H11674

# **Descriptive Report to Accompany Hydrographic Survey H11674**

Project M-T901-AHI-07

Saipan Harbor

Figure 5 – Example of error in line logging.

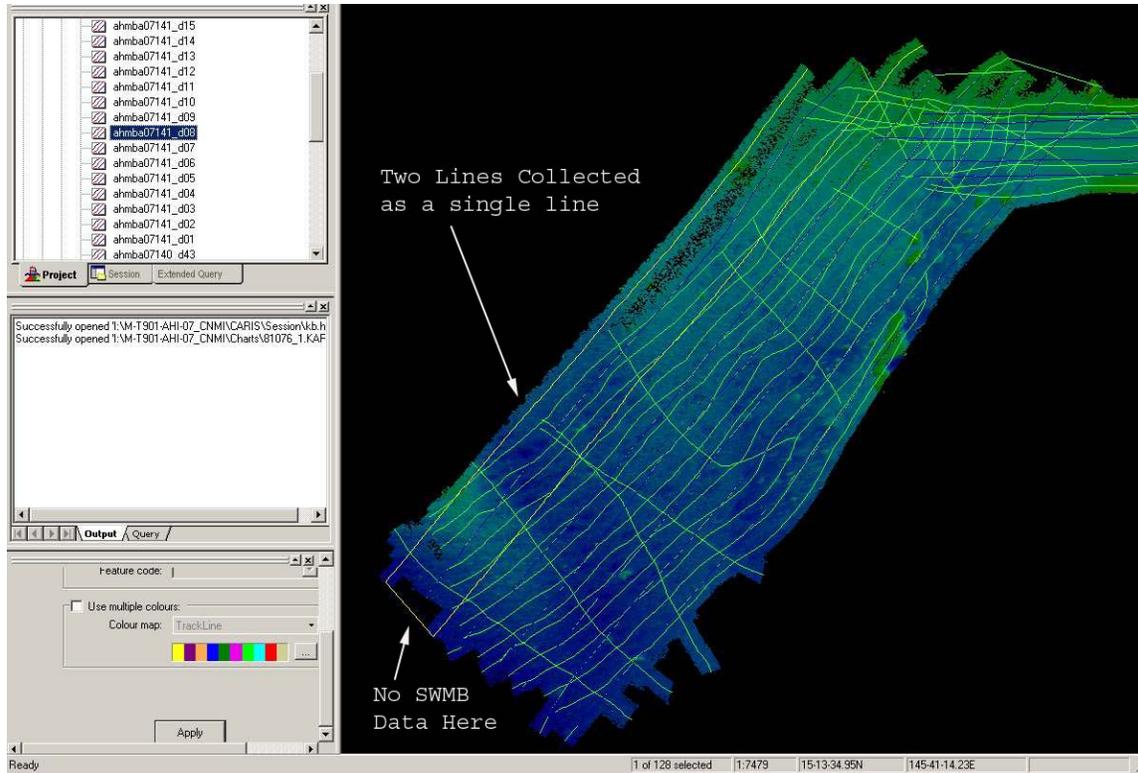
Due to the way data was logged in the ISS-2000 system, separate commands were required to stop data logging and change line names. The command to change lines names was missed on several lines so that what should have been two separate lines appear as a single line in CARIS. These single lines do not contain data in the section connecting the line segments as logging had stopped in between lines. An example of a line collected without changing line names is show in Figure 5<sup>4</sup>.

- <sup>4</sup> This is a data acquisition software issue that has no affect on data quality.
  - <sup>5</sup> Concur, 200% SSS coverage in the absence of small SWMB holidays is acceptable for object detection.

Figure 10

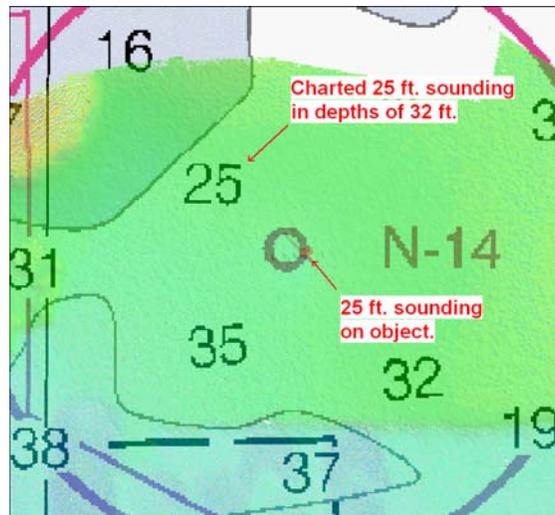
The charted 25 ft. sounding at 15/13/56N, 145/44/03E<sup>14</sup> is located in an area with a depth of 32 ft. This sounding most likely represents the 25ft. shoal point (submitted as a DTON) on the object located approximately 50 meters to the southeast. See Figure 10.

- <sup>14</sup> Chart obstruction as shown in the HCell
  - <sup>15</sup> Chart sounding as shown in the HCell.
  - <sup>16</sup> Chart obstruction as shown in the HCell.

Figure 11

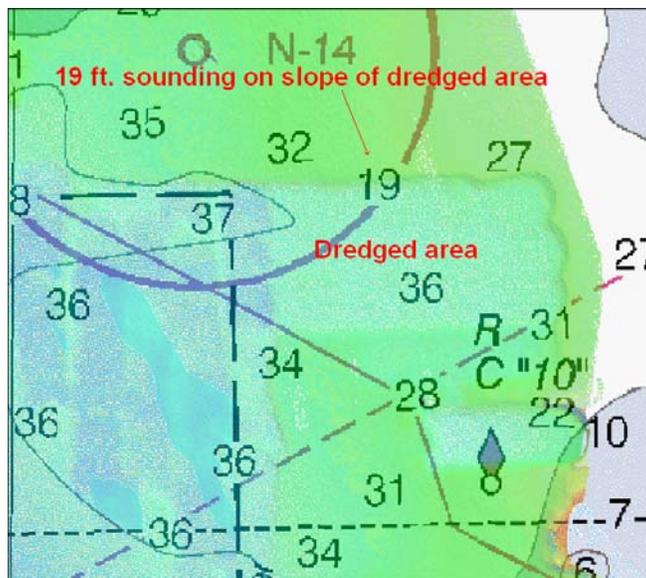
The charted 19 ft. sounding at 15/13/52N, 145/44/08E<sup>15</sup> is located on the slope of a dredged area with depths ranging from 28 to 38 ft. See Figure 11.

Figure 12

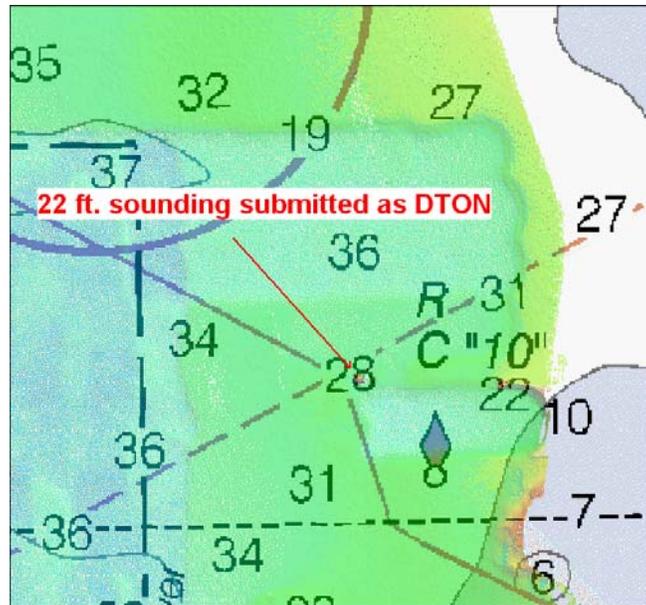
A 22 ft. sounding was found on an object at 15/13/48N, 145/44/09E<sup>16</sup>, over a charted 28 ft. sounding. This sounding was submitted as a DTON. See Figure 12.

Figure 13

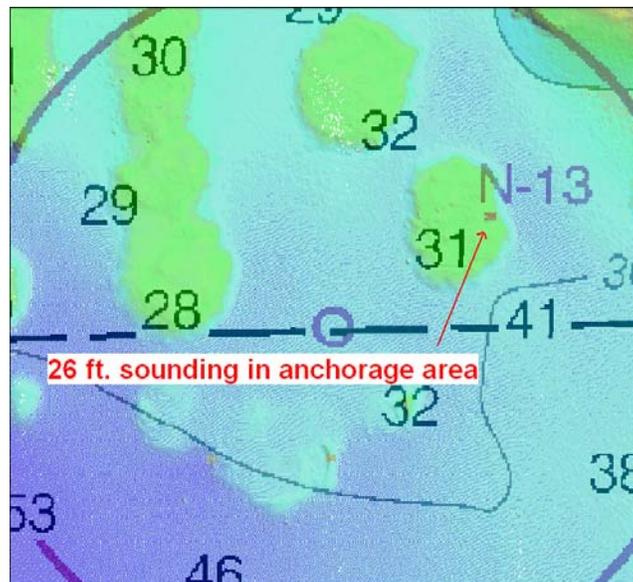
A 26 ft. sounding was found on an object at 15/13/53.6N, 145/43/55.6E<sup>17</sup> in the N-13 anchorage area. This sounding was submitted as a DTON and should be charted as an obstruction. See Figure 13.

- <sup>17</sup> Charted obstruction as shown in the HCell.
  - <sup>18</sup> Chart a 31 ft. sounding as shown in the HCell.
  - <sup>19</sup> Chart the soundings as shown in the HCell

Figure 14

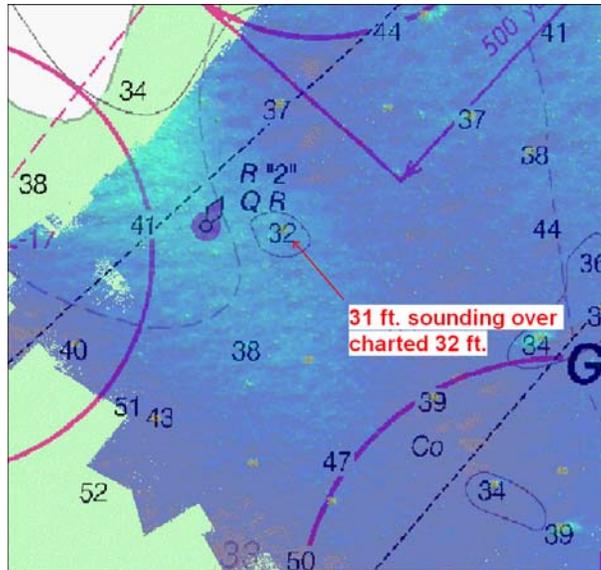
A 31 ft. sounding was found in the outer channel over the charted 32 ft<sup>18</sup> shoal inside of buoy R"2". See Figure 14.

Figure 15

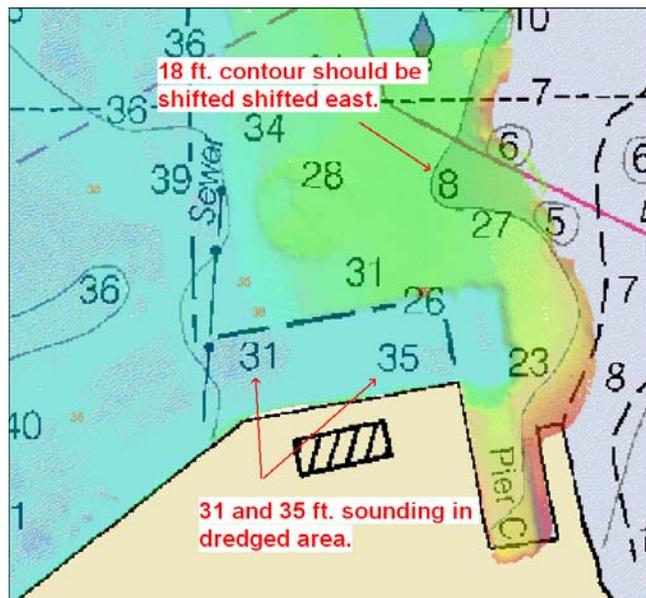
The charted 31 ft. sounding and the 35 ft. sounding located directly north of Pier C at approximate position 15/13/39N, 145/44/08E<sup>19</sup> are located in an area with 40 ft. depths. See Figure 15.

The 18 ft. contour should be shifted to the east at position 15/13/43N , 145/44/11E<sup>20</sup>. See Figure 15.

- <sup>20</sup> Concur with clarification. A charted 8 ft. sounding at 15/14/43.3N, 145/44/11.0E was disproved by 100% multibeam coverage. Chart the area as shown in the HCell.

Figure 16

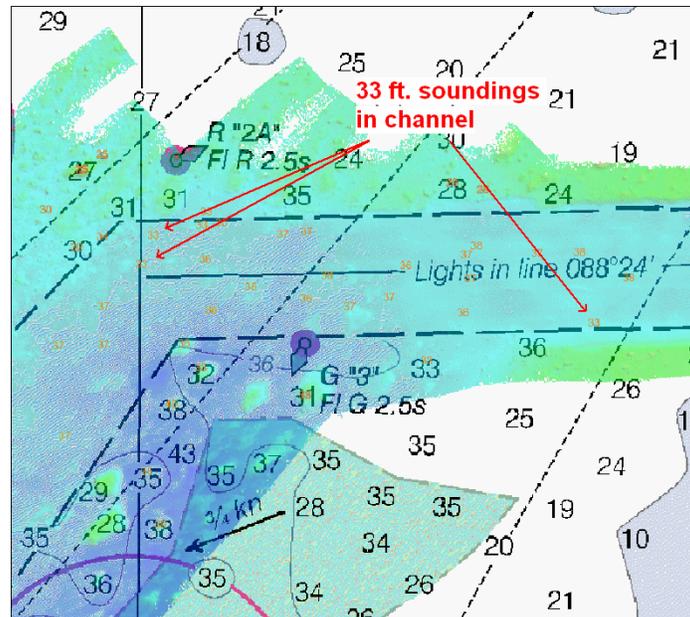
Least depths in the part of the main channel delineated by the dashed line are 33 ft. The 33ft. soundings are located in the NW corner of the channel where it turns to the south and at the edge of the channel at 15/13/40N, 145/42/15.7E<sup>21</sup>. See Figure 16.

- <sup>21</sup> One additional 33 foot sounding within the channel was discovered and selected for charting at 15-13-43.283N, 145-42-02.170E.
  - <sup>22</sup> Concur.
